RFI, Q9 – EIAR, Chapter 4, Human Beings

ACP- 323358-25

Figure 2 – Location of existing wells in relation to the proposed development

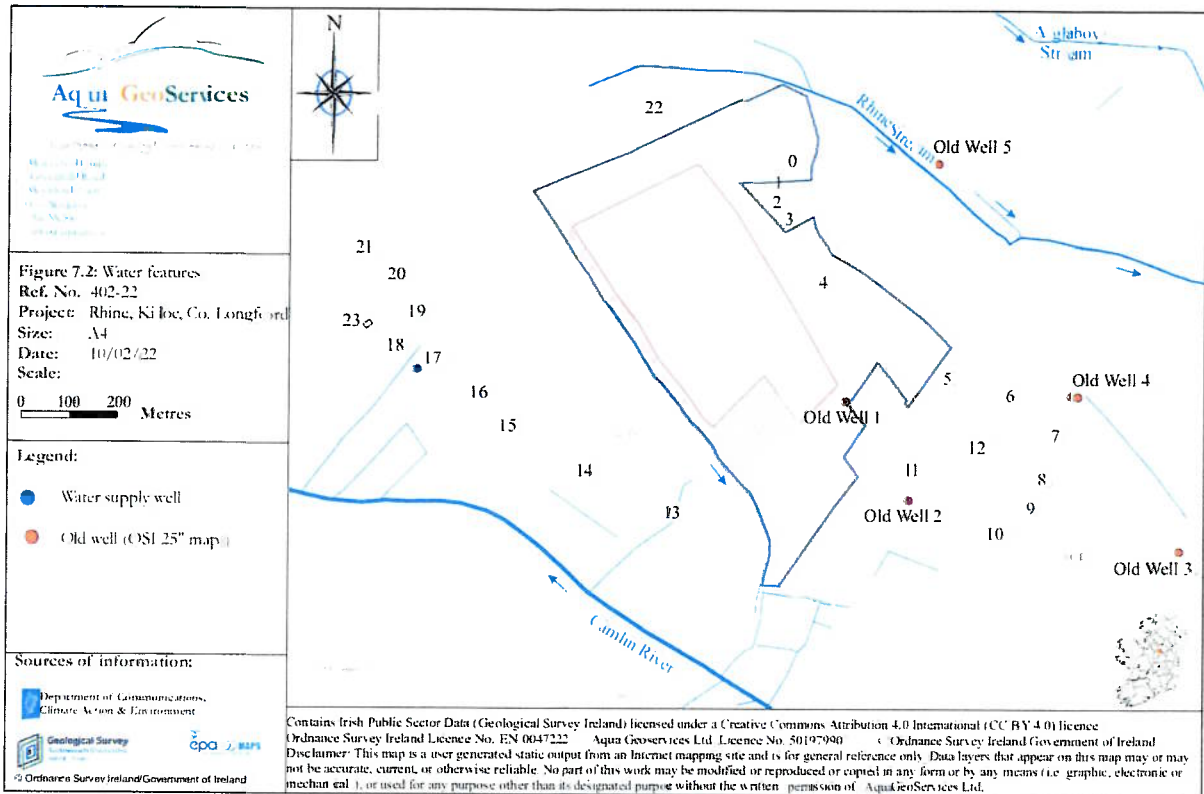
The assessment shall include a review of all the private wells and seek to gain access in order to assess the wells within the area and their risk of impacts from the proposed development.

The location of all wells and ground water sources were assessed and these are shown in figure 2 below. This is a copy of the figure 7.2 (water features) which is shown in Appendix 7.1 of the EIAR.

The GSI national well database (www.gsi.ie) does not show the presence of any private wells in the vicinity of the quarry compound. The site is not located within any EPA / GSI delineated public or private groundwater supply source protection zones.

Notwithstanding the results of the above, a walkover well survey covering a radius of 350m around the boundaries of the proposed site was carried out by the AGS hydrogeologist and the locations of all wells including the old wells, which were shown on the historical OSI 25" maps were assessed, where possible.
